## SICHERHEITSMITTEILUNG für Gurtzeuge

- herausgegeben: 2021-09-15
- Nummer: 04 / 2021 Firebird Gurtzeuge verstellbarer Hauptgurt
- Bezug: PSB FB 2021-01 vom 15.Sept. 2021
- Betroffene Muster: EVO - Gurtzeuge der Firma Firebird , **alle Muster**  
Omega, Student, V1R1 Evo und Tandem **mit verstellbarem Hauptgurt**

## PRODUCT SERVICE BULLETIN

SUBJECT: Firebird V1R1 EVO Harness container systems with adjustable Main Lift Web

View of new recommended webbing layer construction of stopper

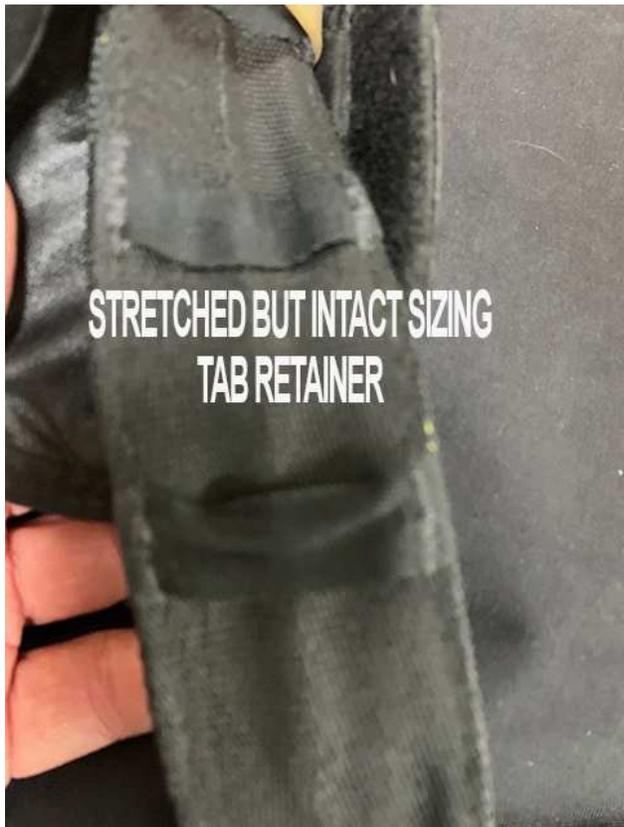
To make sure that in the future only qualified Riggers can disassemble the main lift web, we strongly recommend replacing the type 4 stopper with four layers of type 17 webbing and sew a BOX X pattern with at least 5-cord. Firebird USA LLC uses exclusively 6-cord.

Stitch pattern (5-cord minimum)

USE 5 OR 6 CORD ONLY

### DAMAGES

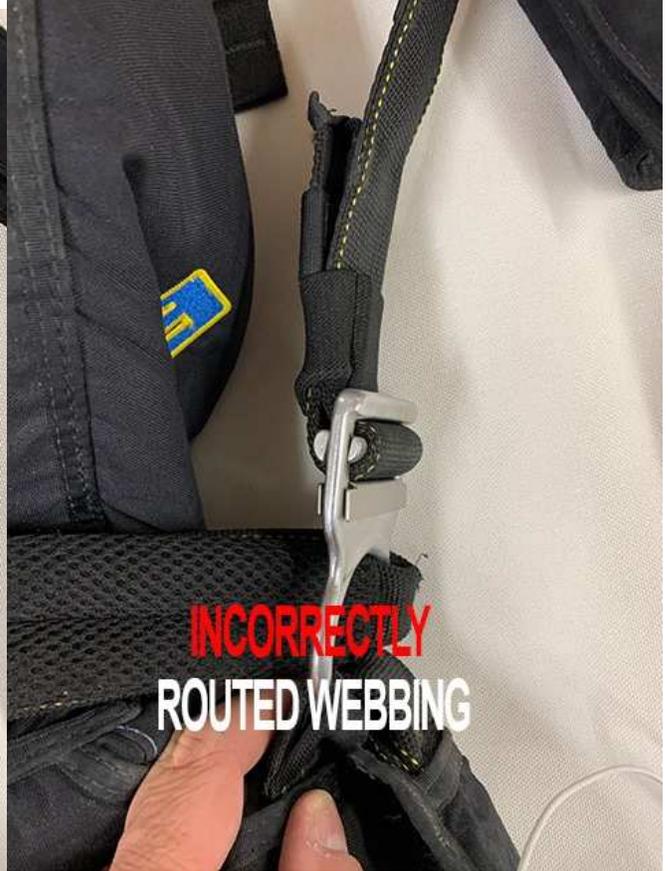
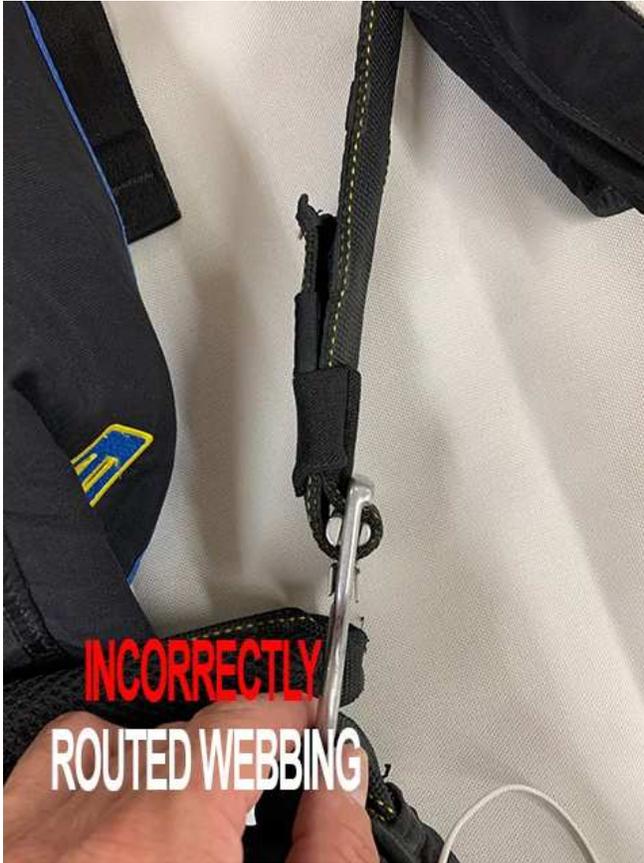
**Right** Main lift web undone, sizing safety tab ripped off and stuck under a stretched but intact sizing tab retainer (1/2" type 1), 555-2 ring installed **correctly**, **missing** spring, **NO** damage to type 4 stopper.

**Left** Main lift web threaded **incorrectly** (double routing, wrong direction, see pics), sizing safety tab attached with only a few stitches (69tex/E thread) ripped, sizing tab retainer stretched but intact, 552-2 ring installed **correctly**, spring present, **NO** damage to type 4 stopper.

**Stretched tab retainer**

**Torn off tab, damage free type 4**
